Work Order ID 105258

Item Name: Skidtube (Fits LH or RH)

DART SERVICE INSTRUCTION

TO AMEND INSTALLATION INSTRUCTIONS IIN-D117-762 REV. A AND
INSTRUCTIONS FOR CONTINUED AIRWORTHINESS ICA-D117-762 REV. 0

SECTION A-A

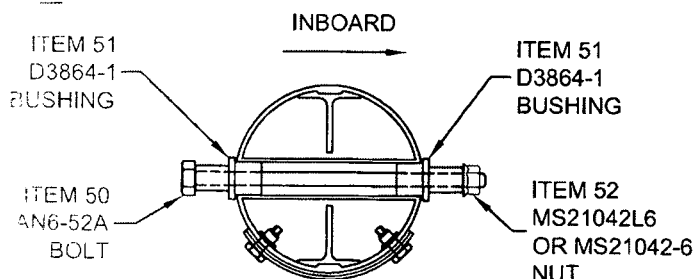
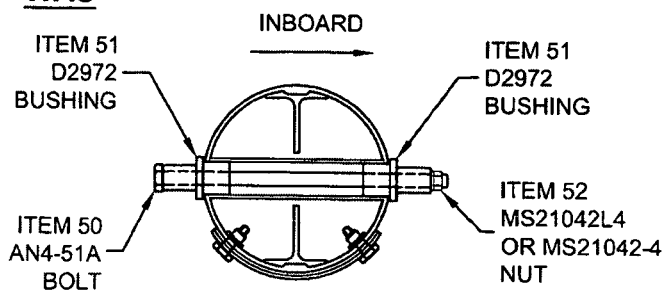
ON D117-762-011 SKIDTUBES AT CHG 002, THE GROUND HANDLING HARDWARE HAS BEEN REPLACED WITH AN6-52A BOLT (1), D3864-1 BUSHING (2), AND MS21042L6 NUT (1) AS SHOWN BELOW. TORQUE TO 95-110 IN-LBS (10.7-12.4 N-M). AMEND PARTS LIST IN SECTIONS 5.1 OF INSTALLATION INSTRUCTIONS IIN-D117-762 REV. A AND SECTION 32.8 OF THE INSTRUCTIONS FOR CONTINUED AIRWORTHINESS ICA-D117-762 REV 0 AS SHOWN ON PAGE 2 OF THIS DOCUMENT.

TO AMEND INSTALLATION INSTRUCTIONS IIN-D117-762 REV. A AND
INSTRUCTIONS FOR CONTINUED AIRWORTHINESS ICA-D117-762 REV. 0

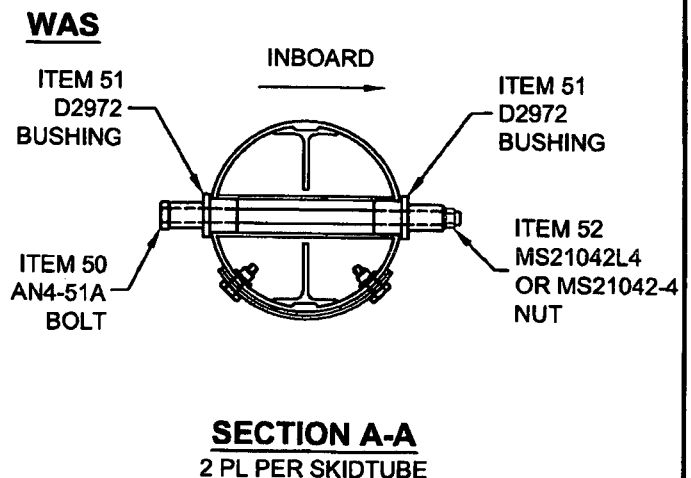
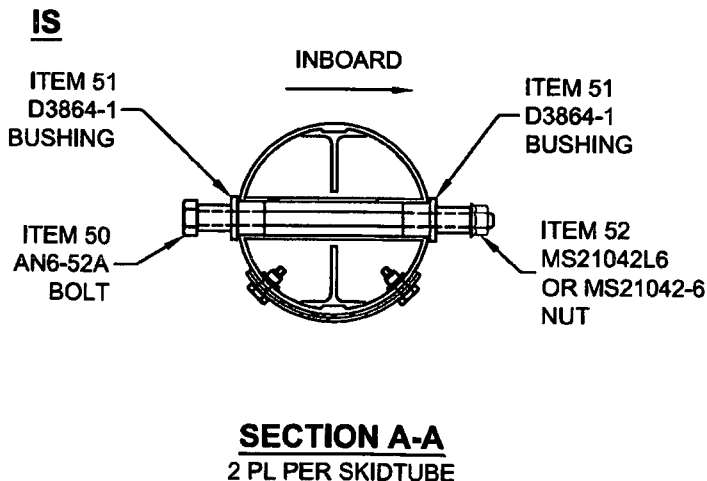
ON D117-762-011 SKIDTUBES AT CHG 002, THE GROUND HANDLING HARDWARE HAS BEEN REPLACED WITH AN6-52A BOLT (1), D3864-1 BUSHING (2), AND MS21042L6 NUT (1) AS SHOWN BELOW. TORQUE TO 95-110 IN-LBS (10.7-12.4 N-M). AMEND PARTS LIST IN SECTIONS 5.1 OF INSTALLATION INSTRUCTIONS IIN-D117-762 REV. A AND SECTION 32.8 OF THE INSTRUCTIONS FOR CONTINUED AIRWORTHINESS ICA-D117-762 REV 0 AS SHOWN ON PAGE 2 OF THIS DOCUMENT.
